Environmental and Social Due Diligence, Impact
Assessment and Road Safety Audit for the Moldova
TEN-T Road Network Rehabilitation Project,
DTM 55768

Date: 2026-05-18

Road Safety Audit
Tranche 1: R7 Road
Lot 1, Lot 2, Lot 3

Figure 5-1. Traffic island marked with horizontal marking (~PC 126+00)

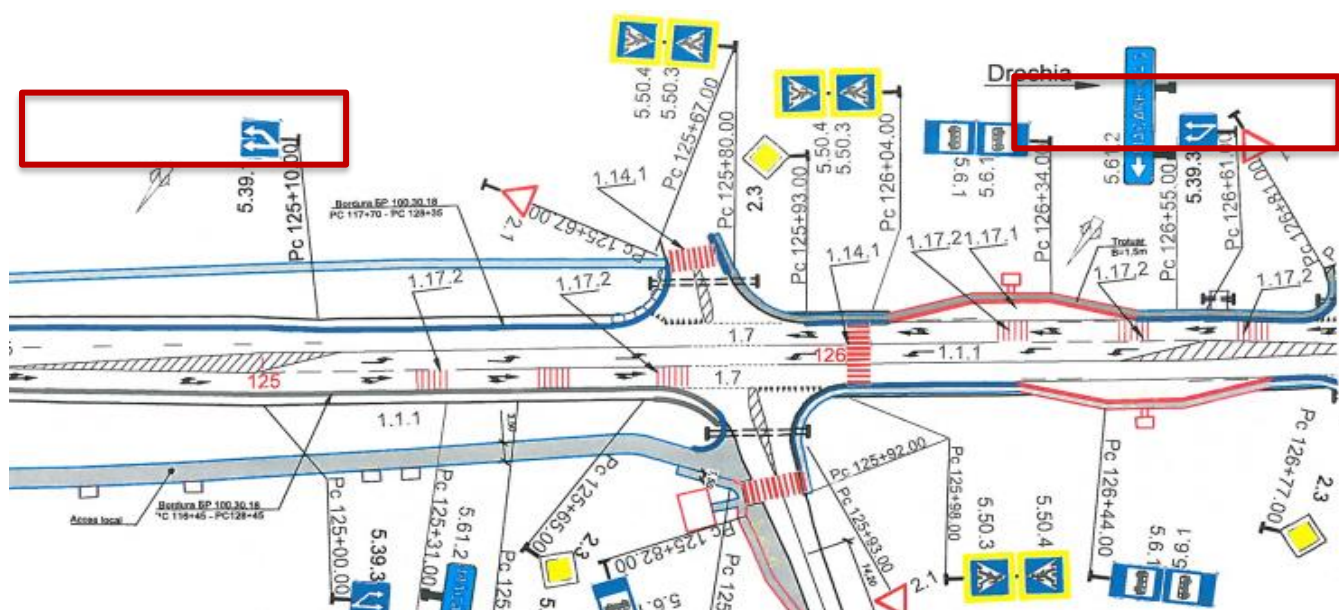
Horizontal road markings alone are not sufficient to reduce speed in junction areas, as drivers often disregard or drive over them. Over time, these markings tend to wear out and lose visibility, especially if they are not regularly maintained or refreshed, making them ineffective in signaling caution or guiding traffic. Similarly, painted safety islands provide limited effectiveness; they are frequently driven over and can even encourage risky maneuvers, reducing their intended safety benefits.

Figure 5-6. Currently designed road safety barriers

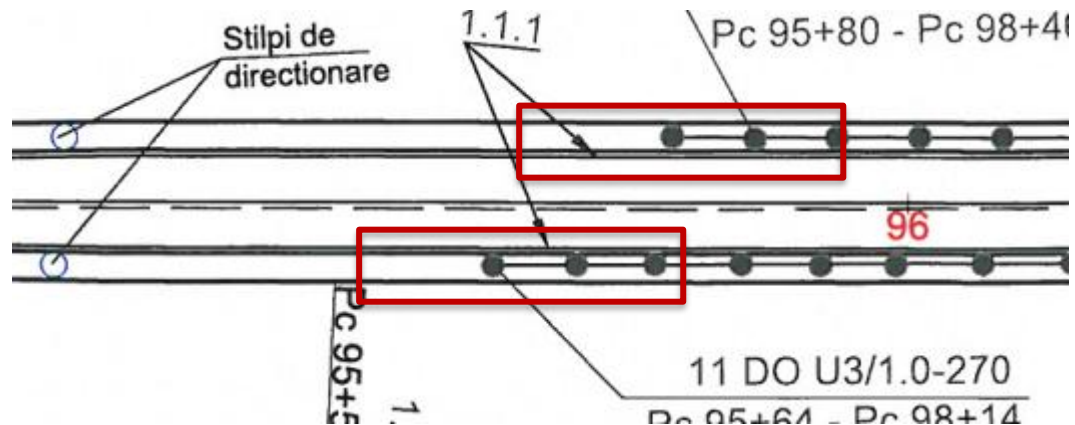
The type of road safety barriers shown in the provided design significant safety deficiencies. Their exposed and unprotected terminal ends pose a severe hazard to road users, particularly at higher speeds. In the event of a collision, these barrier ends can function as rigid, penetrating objects, increasing the likelihood of catastrophic vehicle damage and potentially leading to fatal or life-threatening injuries. Such configurations do not meet modern road safety standards, which require barrier terminals to be designed in a way that absorbs impact energy and prevents spearing, overturning, or abrupt vehicle deceleration.

Figure 5-10. Currently designed layouts of roundabouts

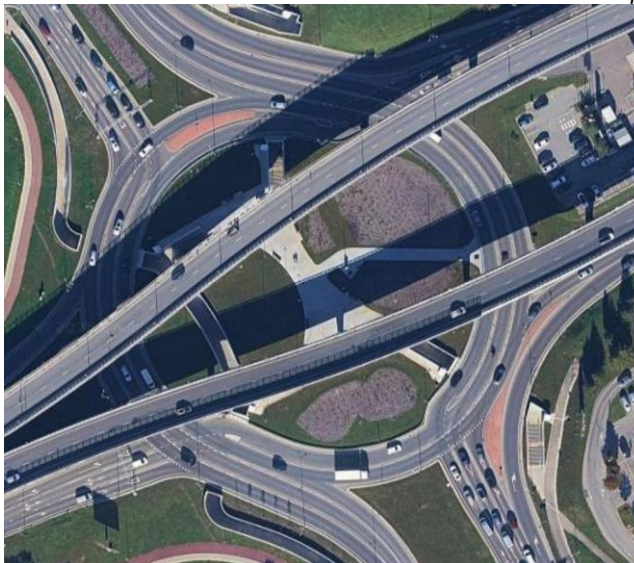
It is strongly recommended to revise the current approach to roundabout design and adopt safer, more modern configurations—especially turbo roundabouts, which provide clearer traffic guidance and significantly reduce the number of conflict points compared to conventional multi-lane roundabouts. Turbo roundabouts are designed with physically or visually enforced lane separation, guiding drivers into dedicated paths and preventing dangerous lane-changing maneuvers within the roundabout. This design not only improves safety performance but also reduces driver stress, particularly in locations with high traffic volumes or complex turning movements. By limiting conflict zones and ensuring predictable vehicle trajectories, turbo roundabouts offer a safer and more intuitive alternative to traditional two- or three-lane roundabouts commonly observed in Moldovan cities and rural areas.

Figure 5-22. Current traffic issues at Romania – Moldova border

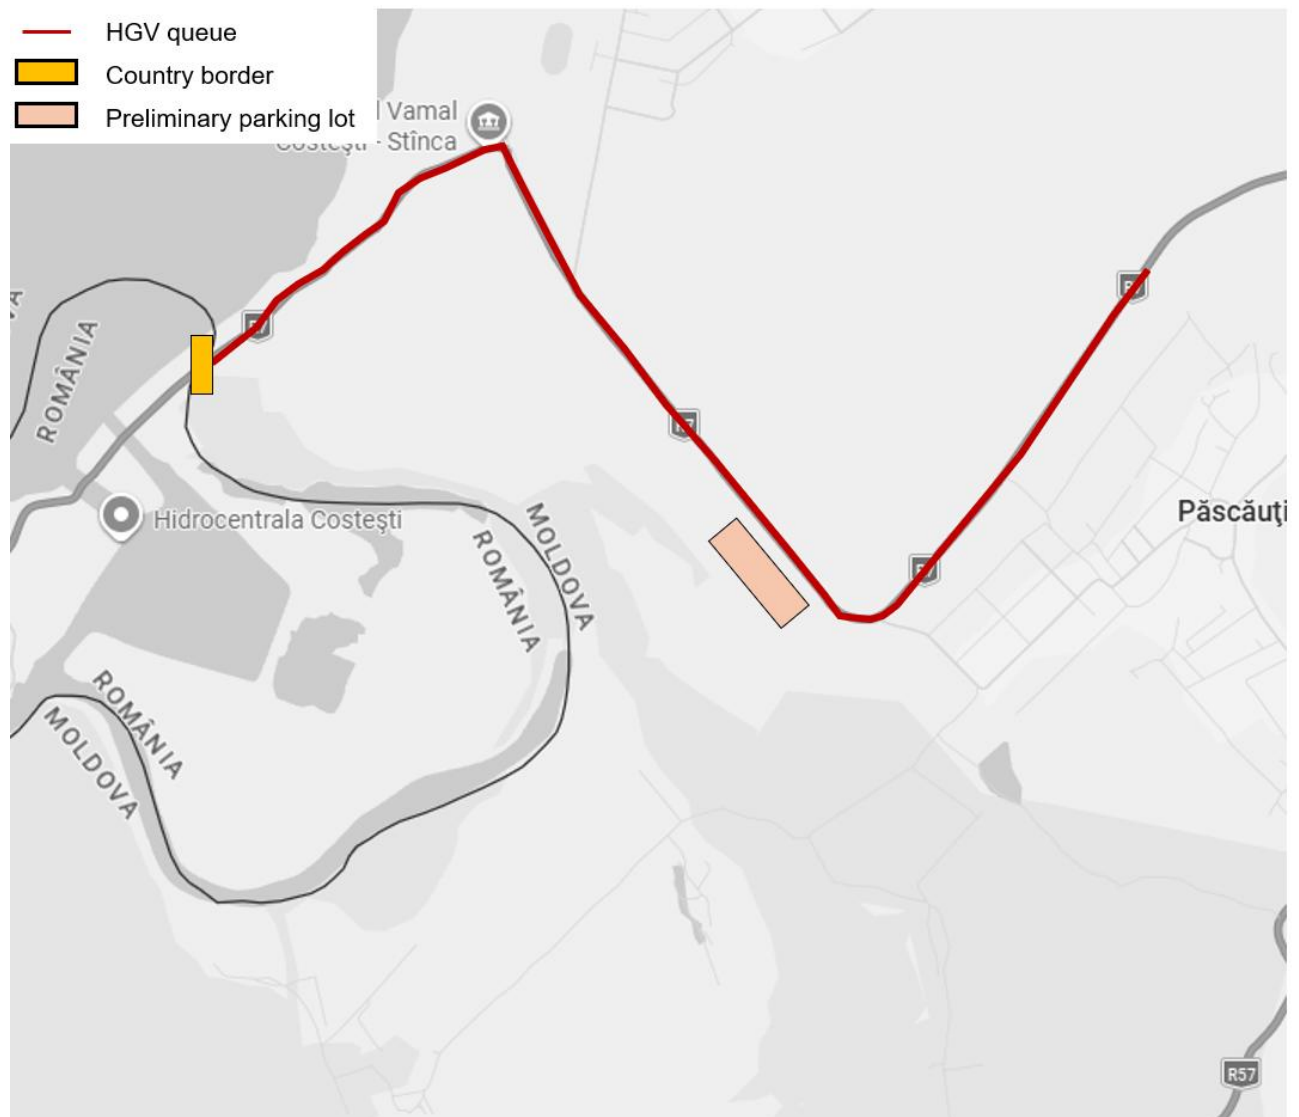
Considering the scale and recurring nature of this issue, it would be reasonable to address not only road safety measures, but also the broader traffic organization and border management system at the Moldova–Romania border near the Costești crossing point. One potential solution would be the development of a dedicated truck waiting and parking area outside the main carriageway, combined with a more advanced border crossing management system. Such a system could allocate scheduled border crossing time slots for freight vehicles, reducing the need for “live queueing” directly on the roadway and significantly improving both traffic safety and operational efficiency along the R7 corridor.

Figure 5-23. Alternative route of R7 nearby Hiliuti

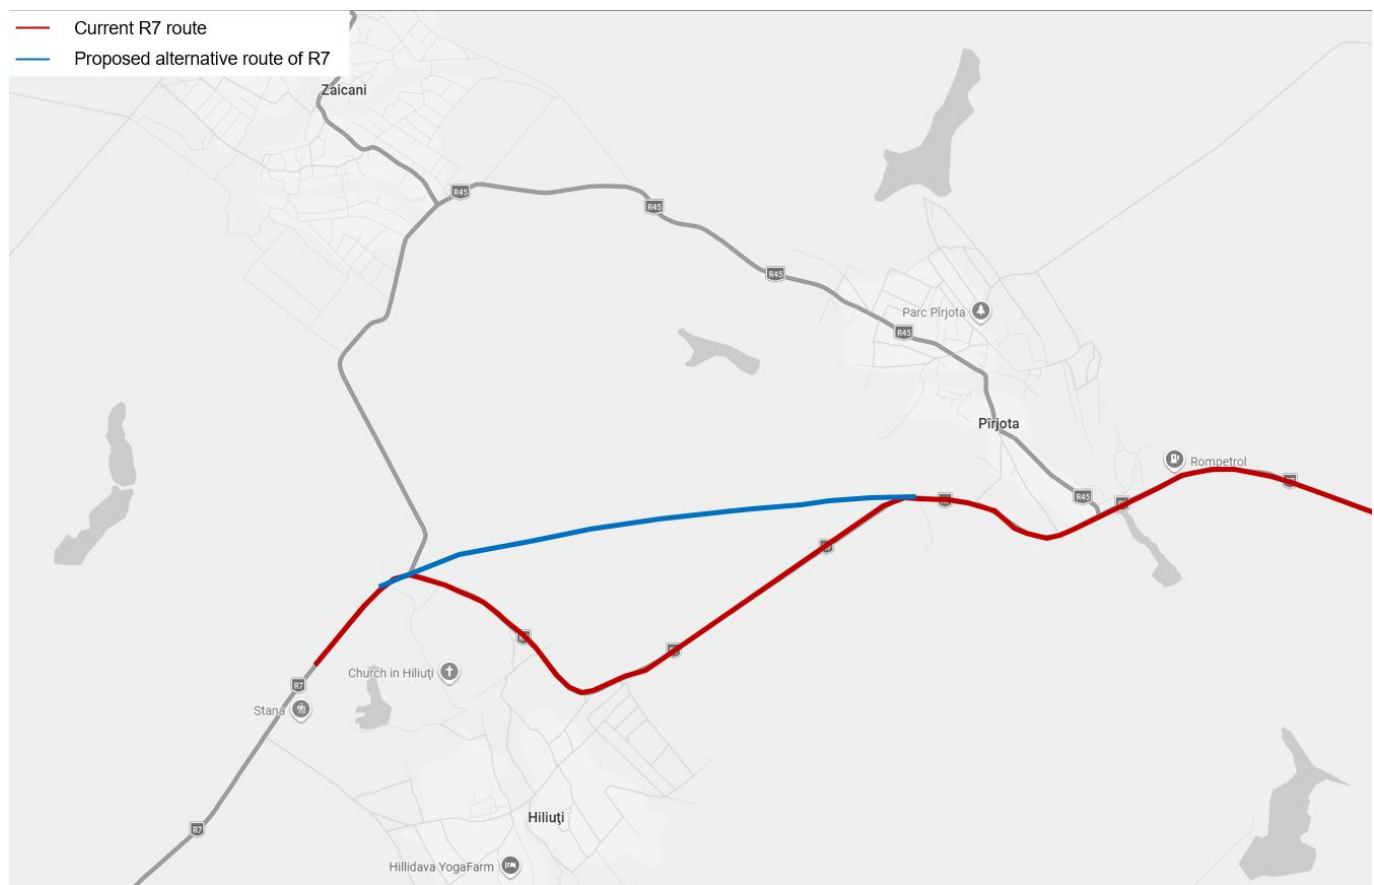
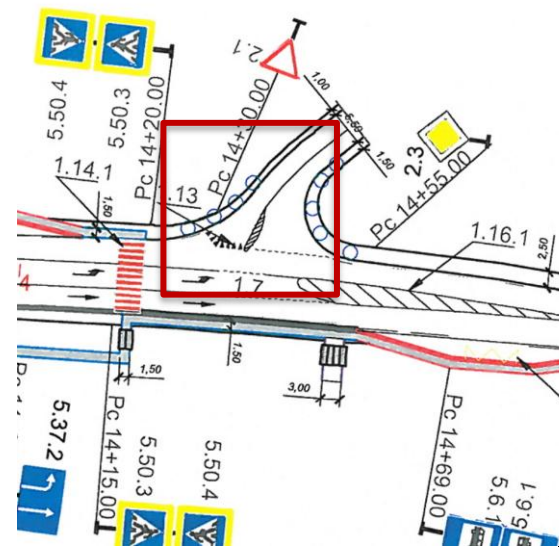
As a result, the community proposed considering a realignment of the R7 route to bypass the Hiliuți settlement entirely, while also avoiding the existing sharp curves. Such a bypass solution could provide multiple benefits for both transit users and local residents. From the transport network perspective, transit traffic would be able to move more efficiently and at more consistent operating speeds by avoiding another settlement section with reduced speed limits, local access movements, pedestrian activity, and geometric constraints. This would improve overall corridor functionality, travel time reliability, and driving comfort for long-distance traffic, including freight transport.

At the same time, removing heavy transit flows from the settlement would significantly improve living conditions for local residents. The reduction of through traffic would decrease noise levels, vibration, dust, and vehicle emissions within the village environment, while also improving pedestrian safety and overall quality of life. Reduced traffic exposure would be particularly beneficial for vulnerable road users, including children, elderly residents, cyclists, and pedestrians moving within the settlement area. In addition, the removal of transit traffic could create opportunities for a more community-oriented street environment with safer local access and improved conditions for future local infrastructure development.

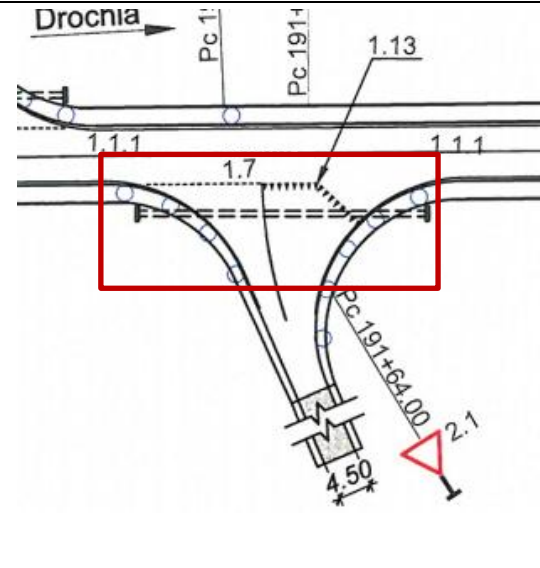
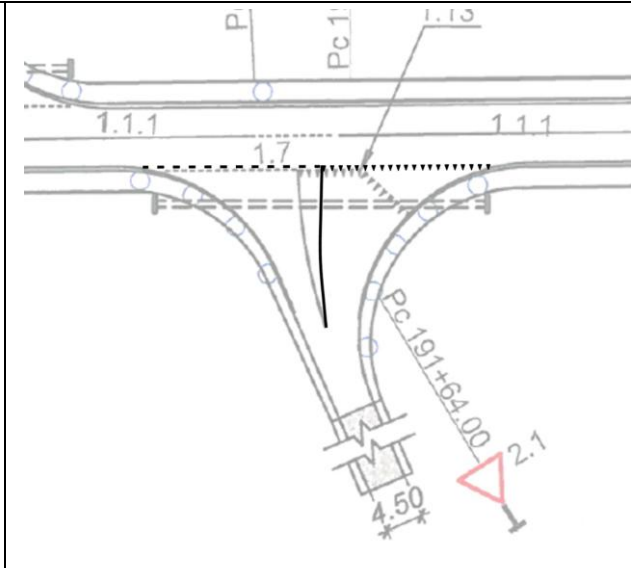
17.	PC 137+00 PC 249+00	When approaching the intersection, it is unclear which directions of travel are permitted from each lane. The lack of clear lane guidance and directional information may lead to confusion among drivers, resulting in disorganized or unsafe maneuvers within the intersection area.	L	It is recommended to mark directional arrows on the pavement and install appropriate road signs in advance of the intersection to inform drivers about the permitted movements from each lane. This will improve traffic organization, reduce uncertainty, and enhance overall safety and efficiency at the intersection.

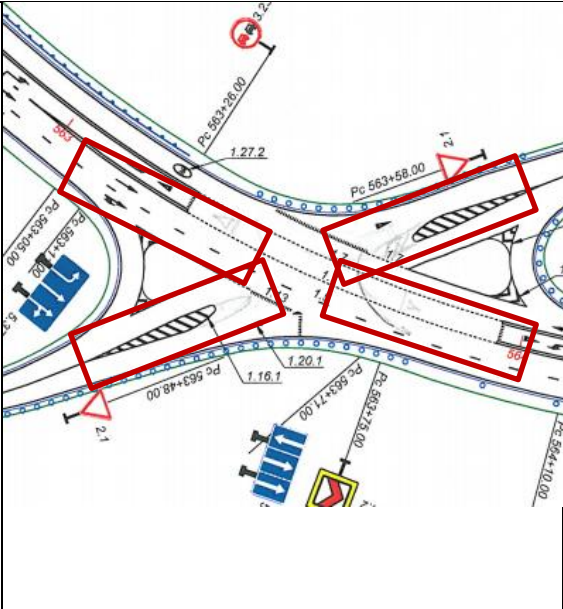
22.	PC 470+37	The designed intersection of the secondary road is not perpendicular to the main road, which may limit the visibility of drivers approaching from the main carriageway.	L	It is recommended to realign the secondary road markings and centerline to achieve a more perpendicular intersection layout. Additionally, assess whether the planned traffic island will effectively serve its intended purpose of separating traffic flows. If not, it is advised to adopt a single-lane configuration at this intersection, avoiding the marking of a separate safety island within the junction area.

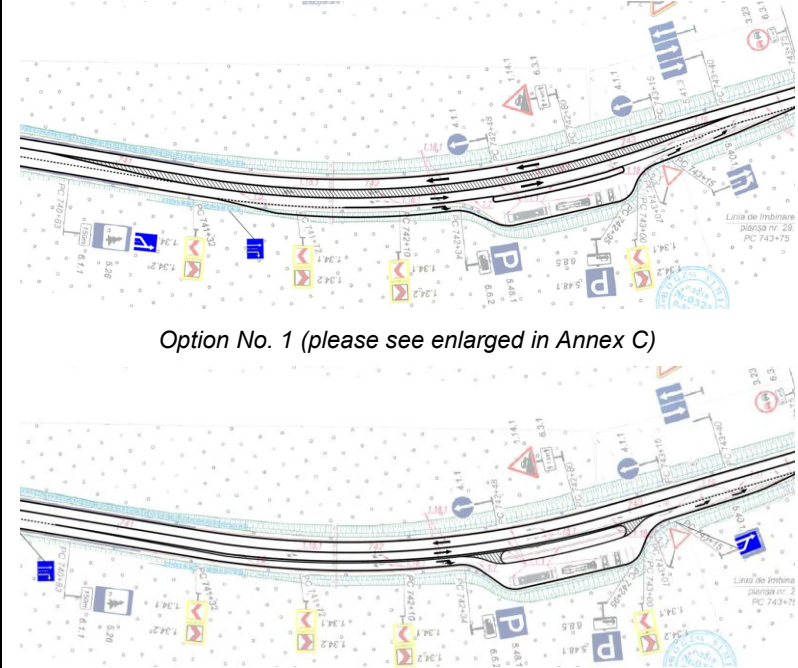
13.	PC 655+43 PC 662+70	The intersection geometry currently deviates from a standard perpendicular four-way configuration. This non-standard design prevents traffic traveling straight across from one minor road to the other minor road from executing the maneuver along a straight trajectory. This geometric constraint can introduce confusion, unpredictability, and increased conflict points, potentially leading to a higher risk of accidents.	L	We recommend, where geometrically and financially feasible, undertaking modifications to realign the intersection to a standard perpendicular four-way configuration. This adjustment would significantly enhance predictability, improve driver visibility, and allow for a straight and direct crossing path for traffic movements, thereby increasing overall intersection safety and operational efficiency.

PC 711+00

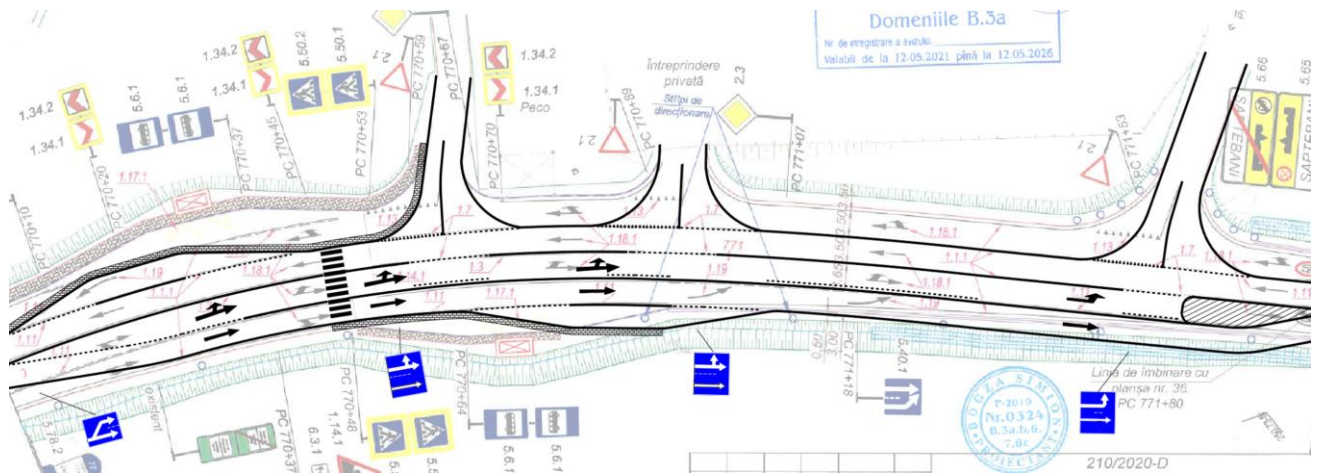
17.	PC 711+00	It is unclear why, in the direction from Costești to Rîșcani, the number of lanes changes near the intersection, extending for approximately 150 meters. A separate lane is provided for the left turn, but the purpose of the additional lane over such a short section is unclear. Additionally, a pedestrian crossing is planned across a wide roadway, spanning four traffic lanes and a bus	H	It is recommended to fundamentally redesign the intersection by providing the necessary number of lanes, ensuring pedestrian safety, designing safe bus stops, and installing appropriate road signs indicating lane directions within the intersection.
